Document Ref: AKL2019-0040AG Rev 1

**RE: SECTION 92 RESPONSE**

**69 TRIG ROAD, 151 & 155-157 BRIGHAM CREEK ROAD, WHENUAPAI**

CMW Geosciences (CMW) have been requested by Neil Construction to provide comments in response to Section 92 queries raised by Auckland Council in relation to the proposed development at 69 Trig Road and 151 & 155 – 157 Brigham Creek Road in Whenuapai.

By	Date	Scale	Job No.	Rev
Surveyed: DS		1:1500@A3	Drawing No.	
Designed: CK			<b>447-01-BE-221</b>	<b>A</b>
Drawn: CK	11/19			
Approved: CK				
CAD FILE F:\PROJECTS\BRIGHAM CREEK TRIGG\DWG\ENG\BULK EW\447-01-EW-220.dwg

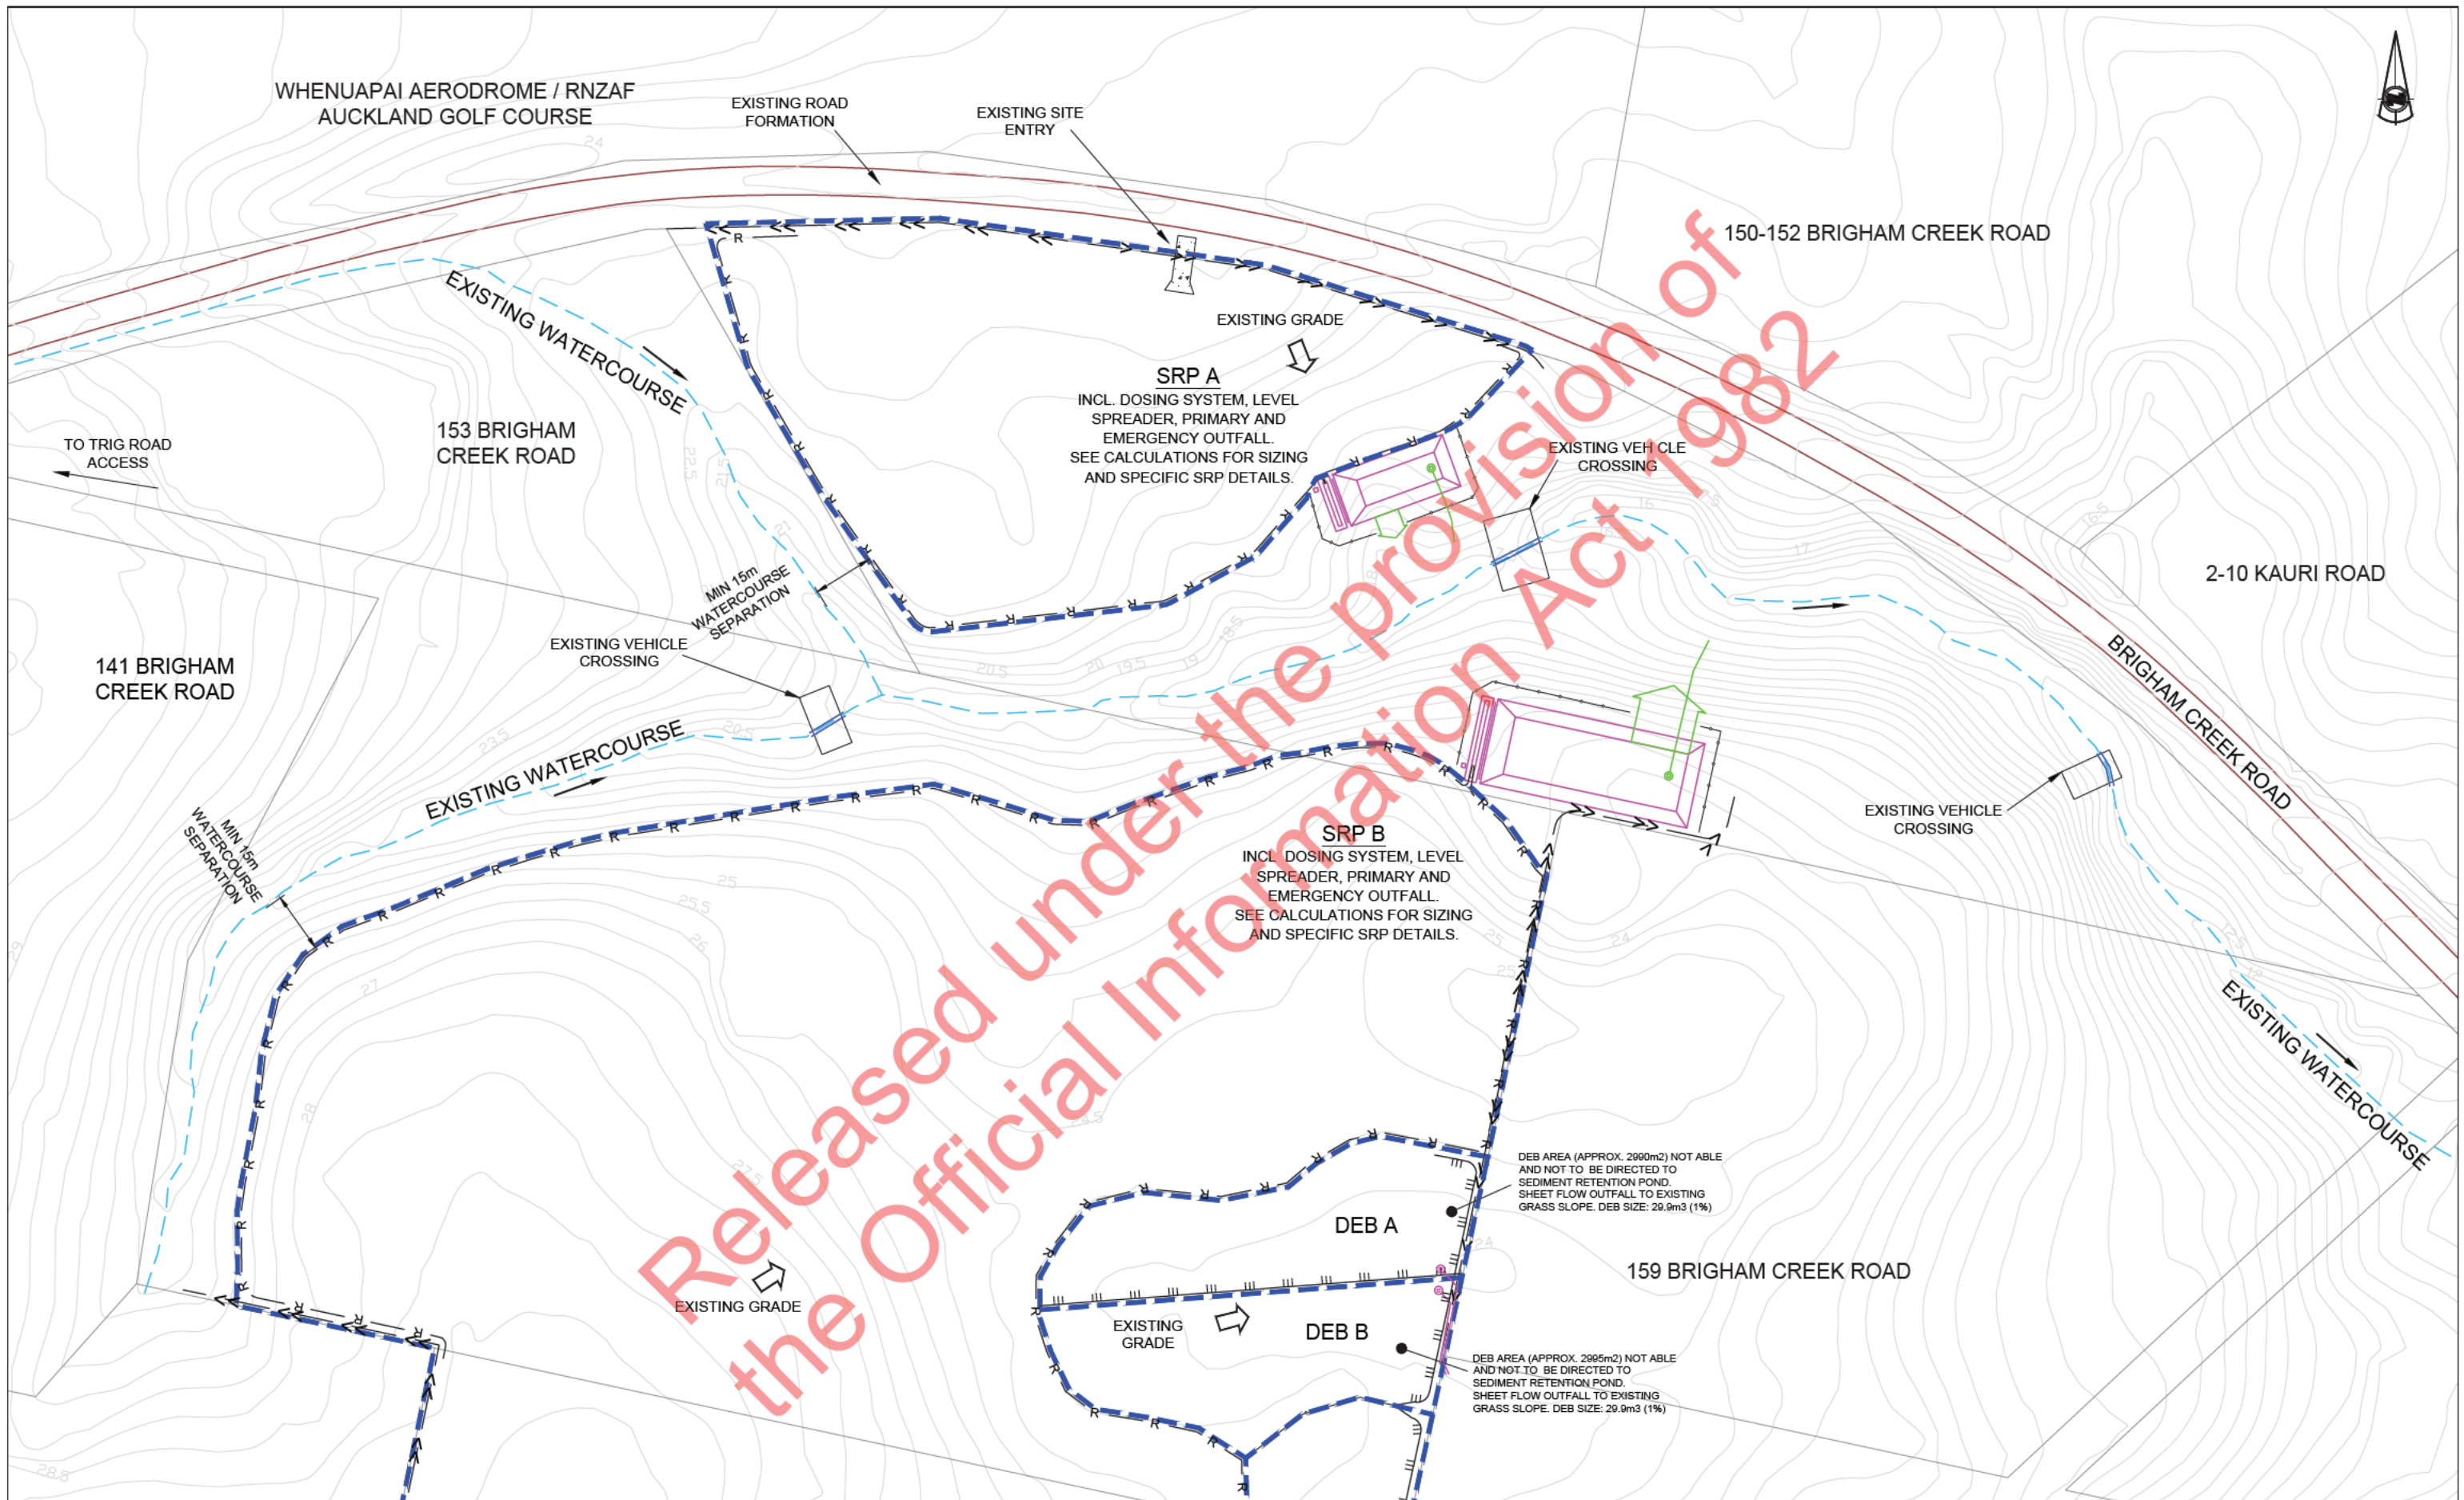
- 1. Please provide geotechnical engineer's input (review and comments) on the location of Sediment Retention Ponds, assessing its location and identifying any risks in terms of the stability of the pond structure itself, due to presence of underlying soils (sic).*
- 2. Please provide revised slope stability assessment of cross section A-A considering post development cross section profile including proposed fill.*

We have been provided copies of the Sediment and Erosion Control plans showing the proposed locations of Sediment Retention Ponds (SRP) A, B and C (Drawings 447-01-BE-221 & 222).

This pond is located in the northern section of the site, within a small gully depression adjacent to the main watercourse. The top of the pond bund is proposed at RL20.0m and construction to this level is expected to require excavation of up to 0.5m on the upslope side and up to 1m of fill along the downslope edge.

There are no signs of inherent instability in the immediate area. However, construction recommendations will include undercutting any soft/organic soil that may be present within the depression, as well as keying of the downslope bund into the natural soil and placement of compacted engineered fill to form this bund.

Inspection of the materials exposed in the pond excavation is recommended. Any sandy/silt materials encountered shall be undercut and replaced with clay rich materials to minimise the potential of piping through the sandy materials.

This pond is located on a relatively flat area, at the junction of the boundaries for 151, 155-157 and 159 Brigham Creek Road, above a slope which drops into the main watercourse at gradients of up to 1 in 4 (V:H). The top of the pond bund is proposed at RL21.5m and construction to this level is expected to require excavation of between 0.5m and 1.5m.

There are no signs of inherent instability in this location, and the excavations required to form the pond will reduce the load on the slope below, increasing the stability of the immediate area.

Inspection of the materials exposed in the pond excavation is recommended. Although unlikely, any sandy/silt materials encountered shall be undercut and replaced with clay rich materials to minimise the potential of piping through the sandy materials.

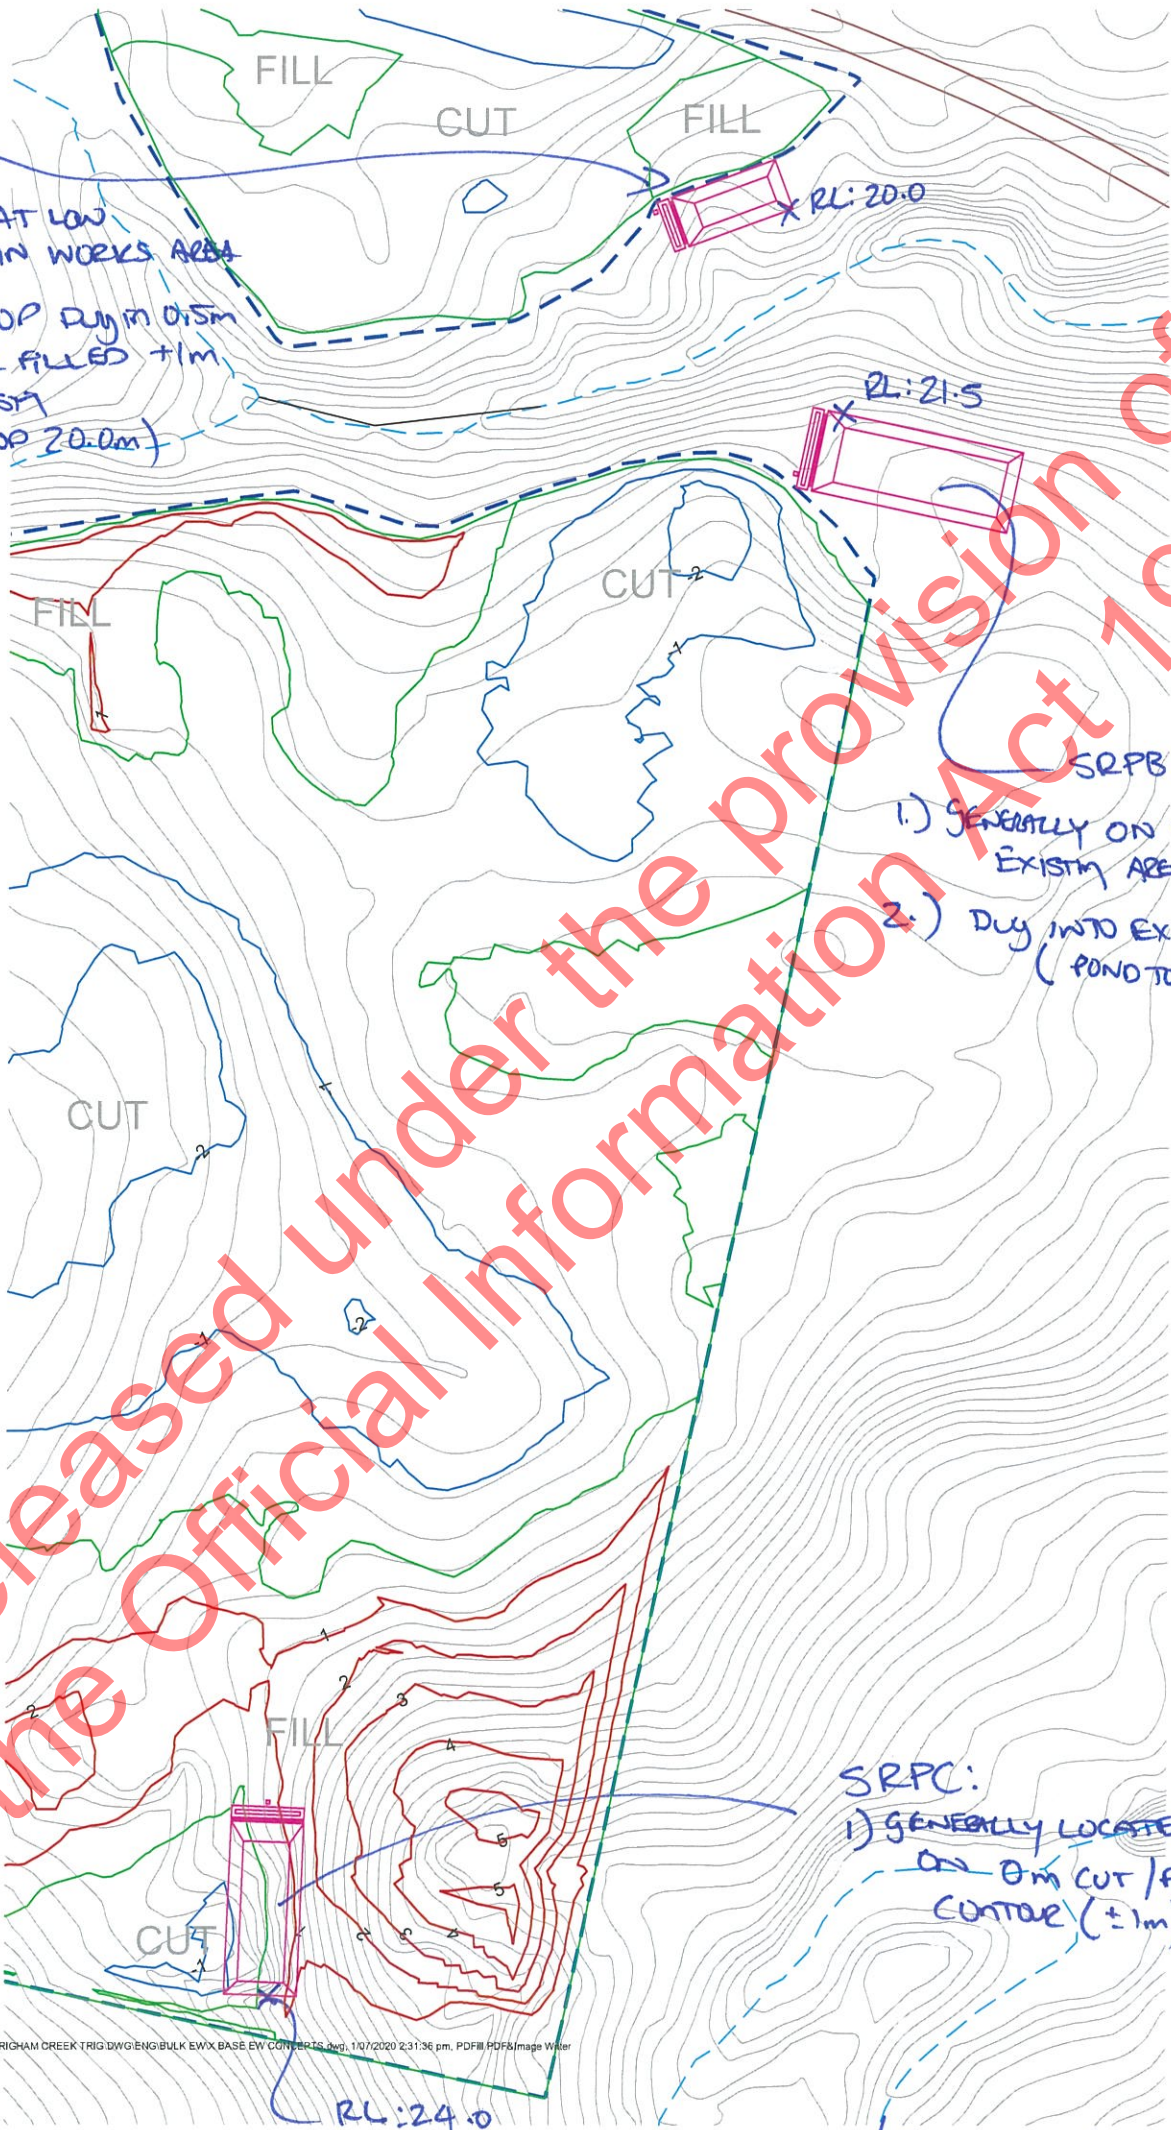
In addition, we have been provided with sketched overlay of the pond locations in relation to the existing contours and cut/fill contours, with details of the proposed SRP levels and locations.

SRPA:

- 1.) LOCATED AT LOW POINT IN WORKS AREA
- 2.) POND TOP DUG IN 0.5m AND/OR FILLED +1m TO EXIST (POND TOP 20.0m)

SRPB:

- 1.) GENERALLY ON FLAT EXISTING AREA.
- 2.) DUG INTO EXISTING (POND TOP RL: 21.5)

SRPC:

- 1.) GENERALLY LOCATED ON 0m CUT/FILL CONTOUR (±1m)
